**Bayside Planning Panel**

Item No	<b>6.6</b>
Application Type	Development Application
Application Number	DA-2017/195
Lodgement Date	02/12/2016
Property	<b>1 Bruce Street, Bexley</b>
Owner	Shao Ying Pty Ltd
Applicant	Morning Sunshine Kids Academy Pty Ltd
Proposal	Alterations and additions to existing dwelling and conversion into a childcare centre with capacity for 32 children operating 7.30am to 6pm Monday to Friday
No. of Submissions	17 individual submissions and 1 petition with 27 signatories
Cost of Development	\$300,000.00
Report by	Fiona Prodromou – Senior Assessment Planner

## Planning Assessment Report

<b>Application Number:</b>	DA-2017/195
<b>Date of Receipt:</b>	2 December 2016
<b>Property:</b>	1 Bruce Street, BEXLEY (Lot 2A DP 318502), (Lot A DP 350797), (Lot B DP 350261)
<b>Owner:</b>	Shao Ying Pty Ltd
<b>Applicant:</b>	Morning Sunshine Kids Academy Pty Ltd
<b>Proposal:</b>	Alterations and additions to existing dwelling and conversion into a childcare centre with capacity for 32 children operating 7.30am to 6pm Monday to Friday
<b>Recommendation:</b>	Refused
<b>No. of submissions:</b>	17 individual submissions and 1 petition with 27 signatories
<b>Author:</b>	Fiona P

Figure 3 – Barrier Systems

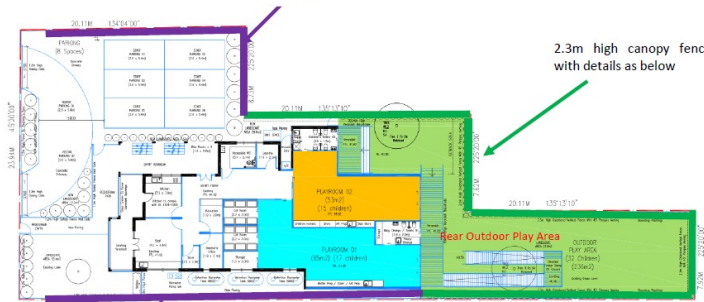
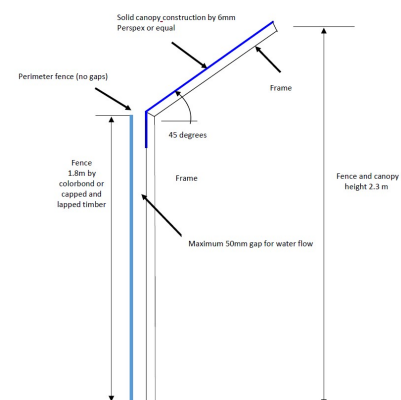
The required overall height (2.3m) of acoustic fencing to the periphery of the outdoor play areas in order to mitigate acoustic impacts to residential neighbours, is a direct consequence of the residential

The applicant submitted a revised Acoustic Report undertaken by Acoustic Logic dated 19 July 2016. The outdoor play noise within the report was predicted based on the assumptions below:

1.8m high vertical fence which can be constructed by colorbond or lapped capped timber

2.3m high canopy fence with details as below
